Russell S. Long
USSN 10/662,112
Filed September 12, 2003

Remarks

Application No. 10/662,112
Amendment dated August 18, 2005
Reply to Office Action of May 19, 2005

Annotated Sheet Showing Changes

FIG. 4

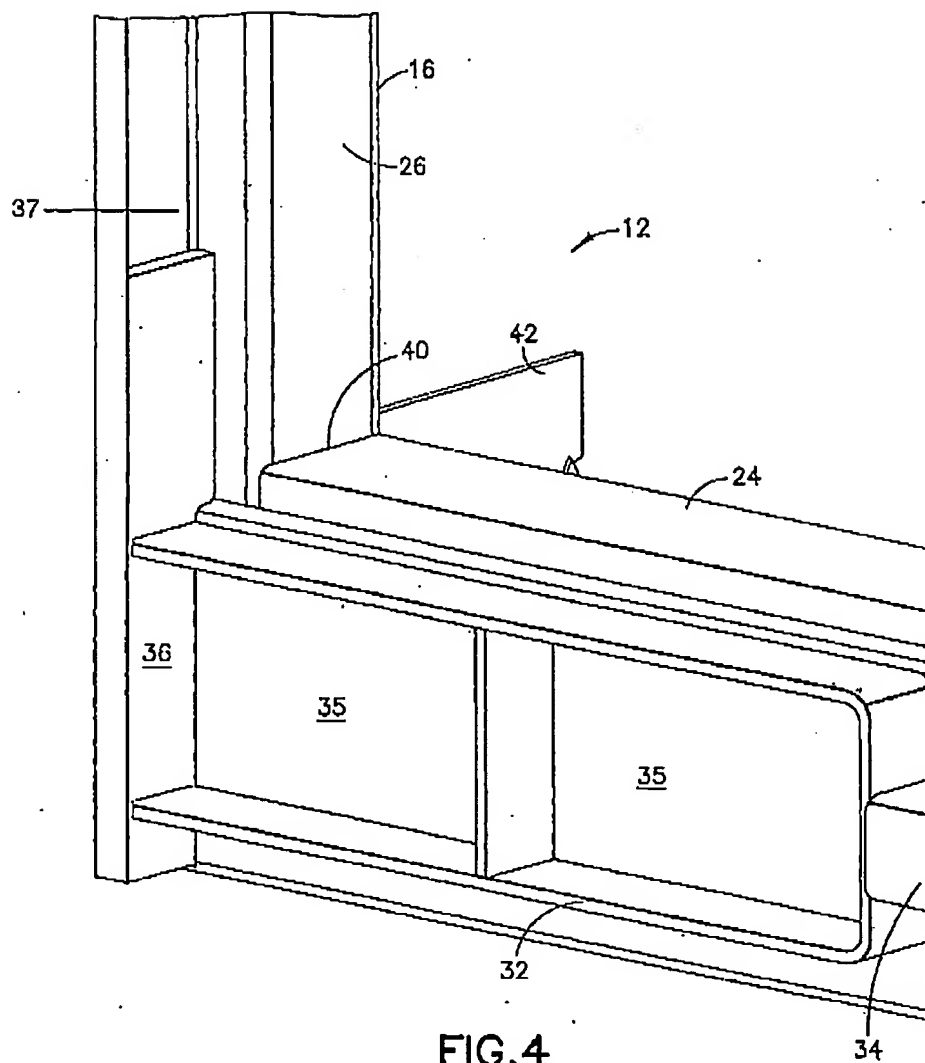
Applicants have amended FIGS. 2 and 4 by adding reference numeral 37. Reference numeral 37 points to a groove that extends substantially along the entire length of the exposed side of each side rail. Groove 37 is adapted to receive the stiffener member 36. The groove 37 was depicted in the original figures that were transmitted with the application. However, the groove 37 was not given a reference numeral.

Accordingly, Applicants have amended paragraph [0038] to state that the stiffener members 36 are received into a groove 37 that extends substantially along the entire length of the exposed side 18 of each side rail 62. Because the groove 37 was depicted in the original drawings that were filed with the application, the amendment to paragraph [0038] does not present an issue of new matter under MPEP Section 2163.06.
